[11] Patent Number: **5,457,435**
[45] Date of Patent: **Oct. 10, 1995**

[54] PULSE WIDTH MODULATED DRIVER

UNITED STATES PATENT AND TRADEMARK OFFICE
CERTIFICATE OF CORRECTION

FIG. 2

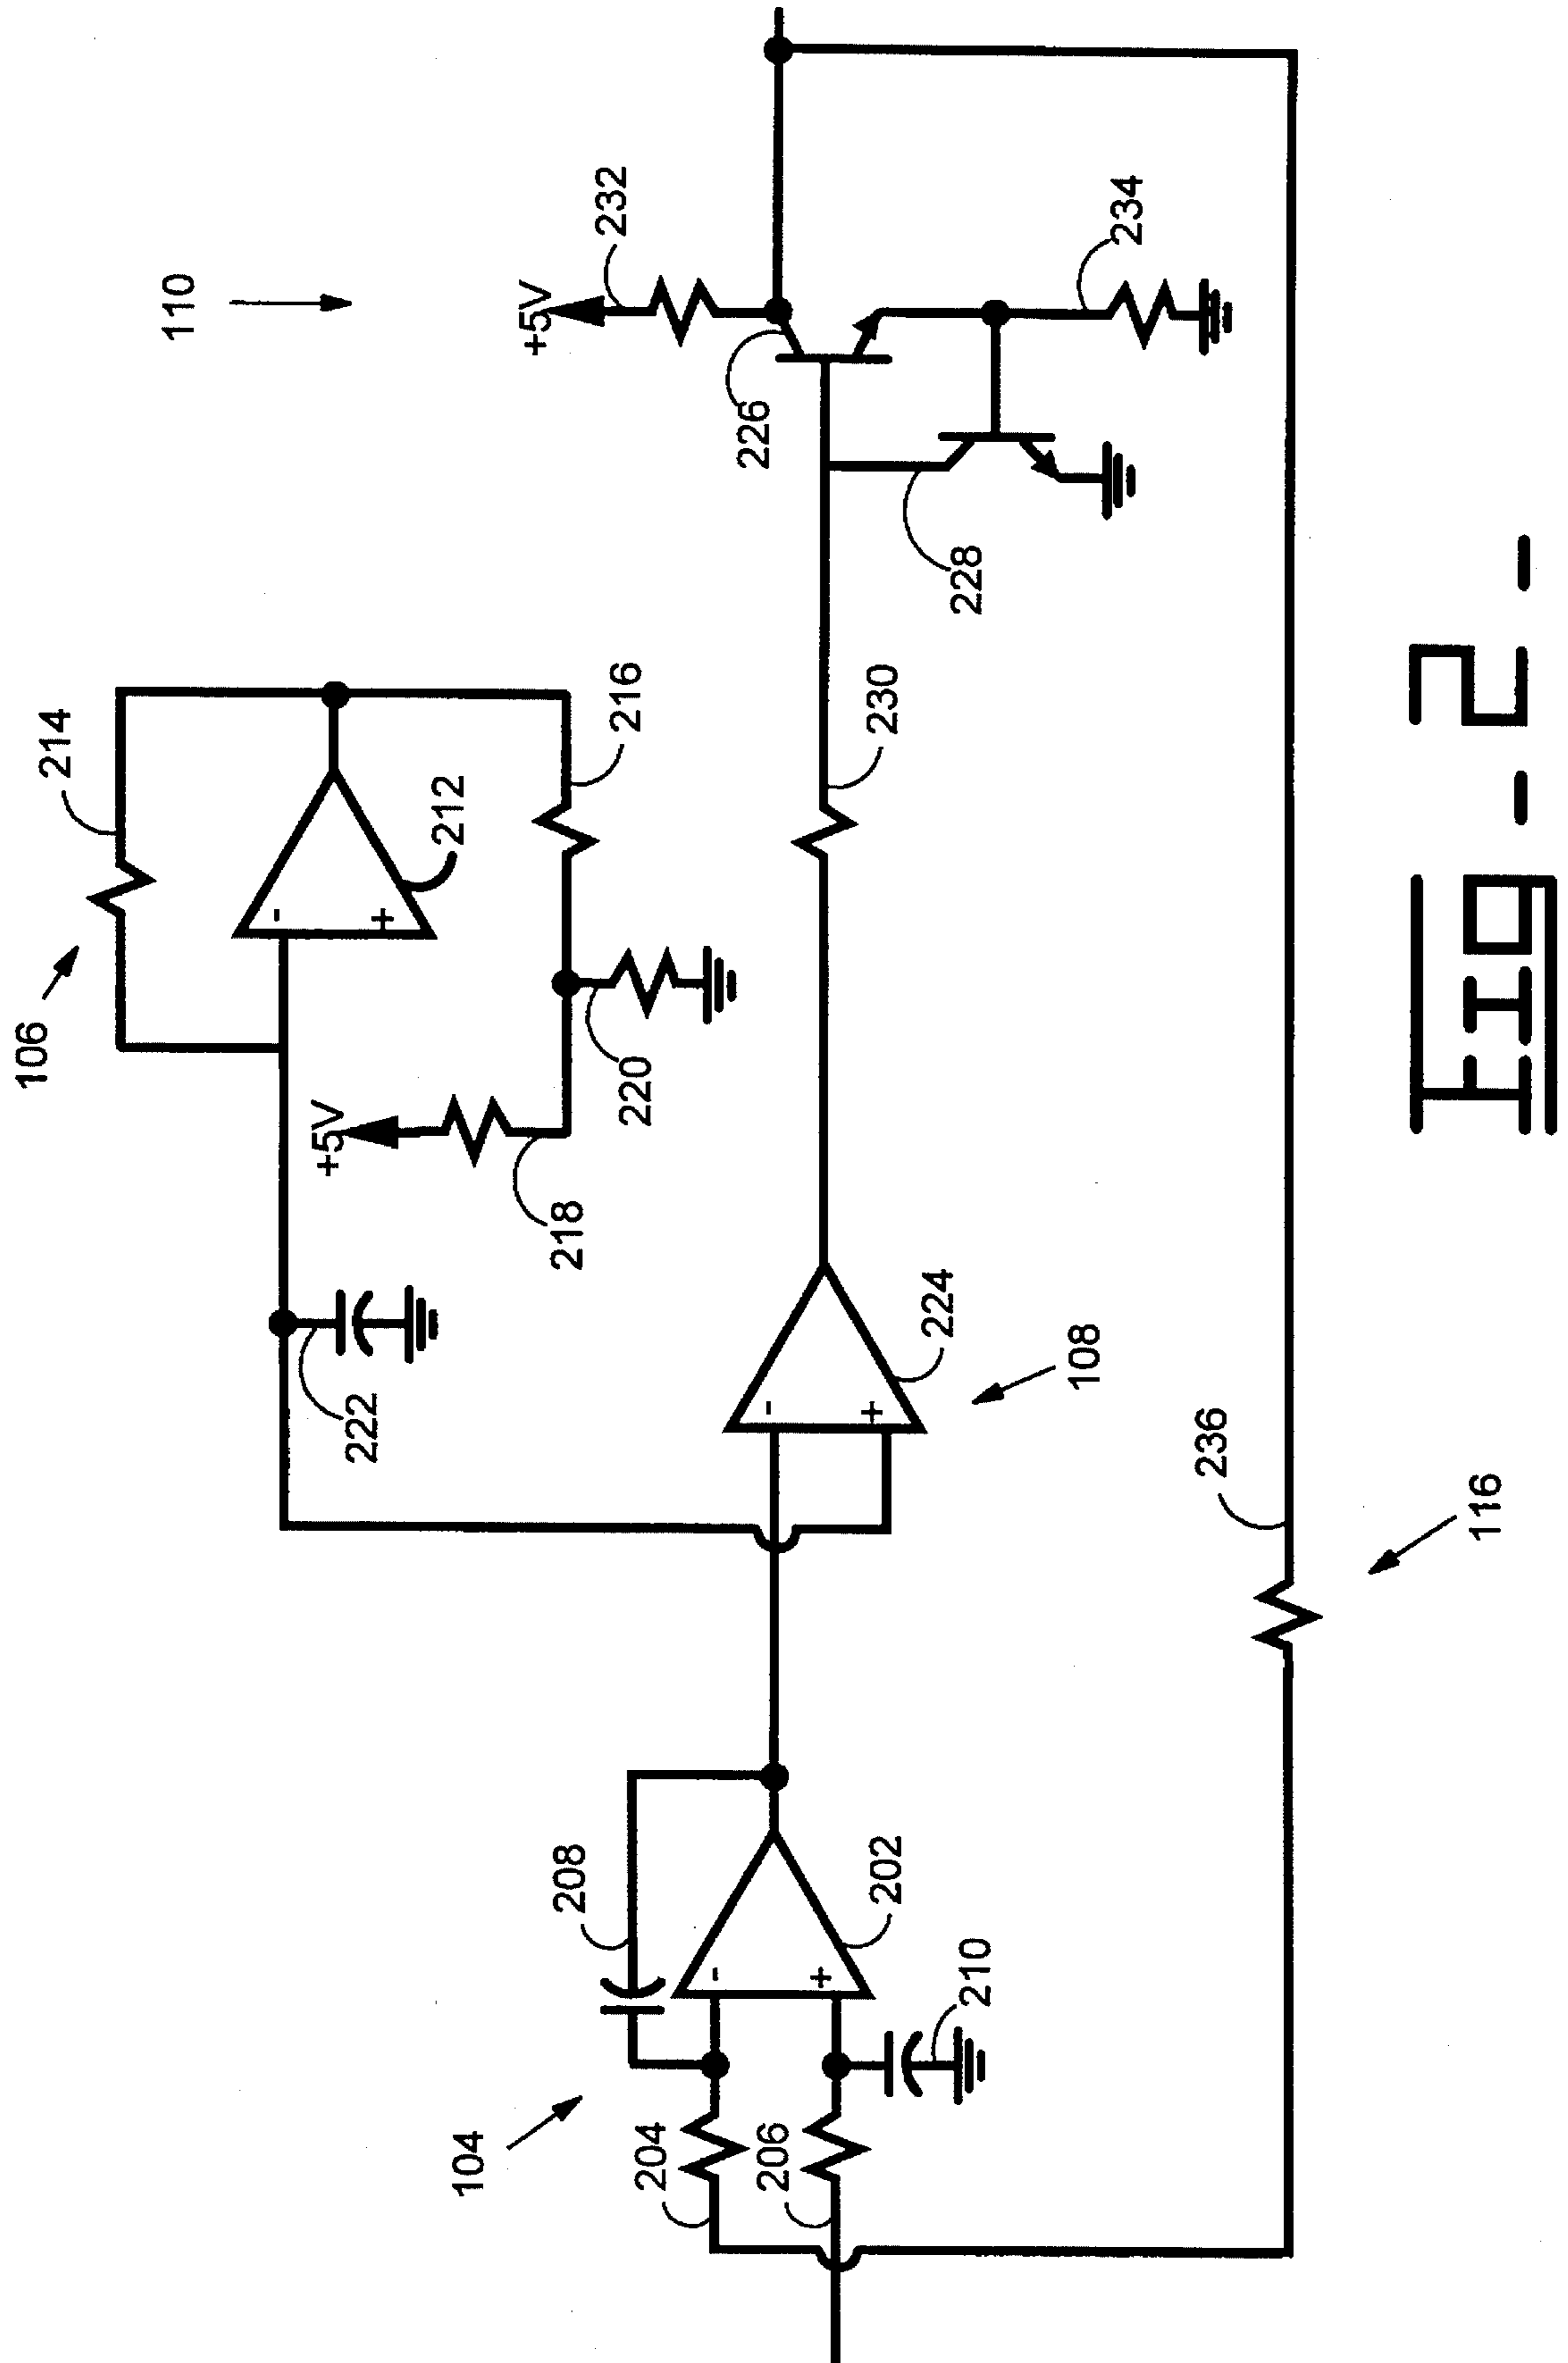
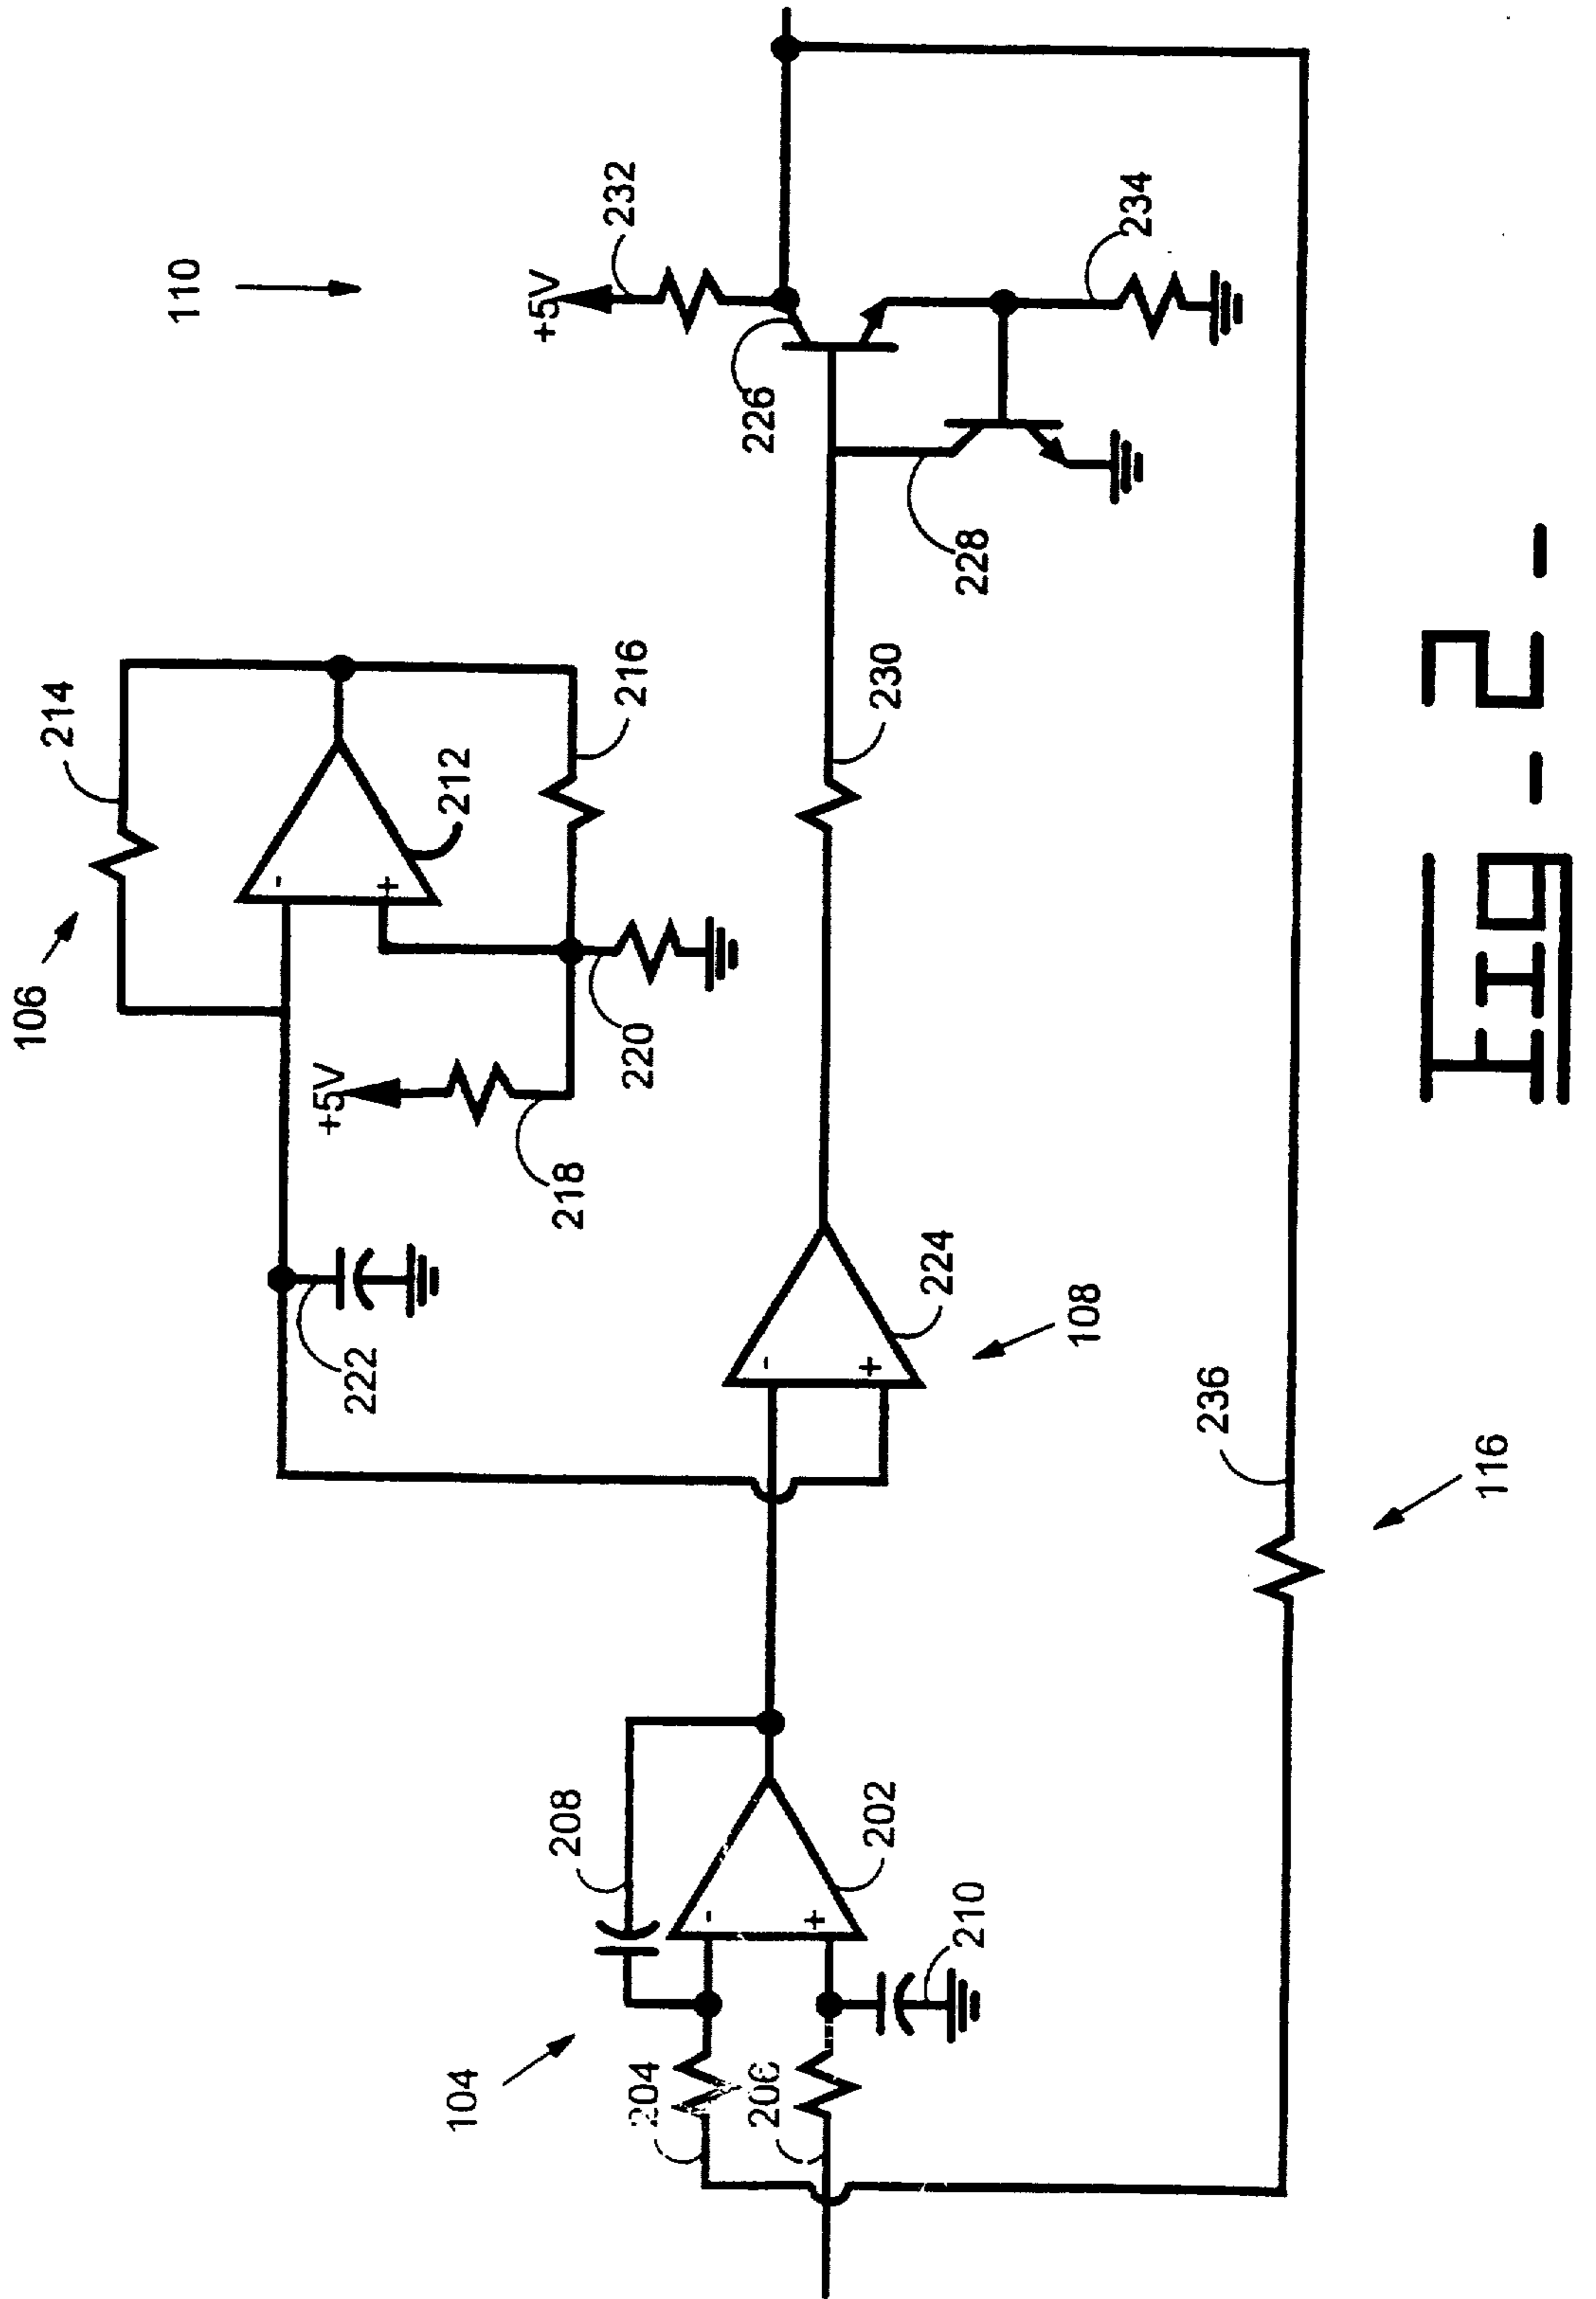
Column 2, lines 38-40,

"A sixth resistor 220 is connected between the juncture of the fourth and fifth resistors and electrical ground and to a positive input terminal of the first comparator 212."

In Fig. 2, the connection from the juncture to the positive input terminal of comparator 212 was omitted. A corrected Fig. 2 is attached.
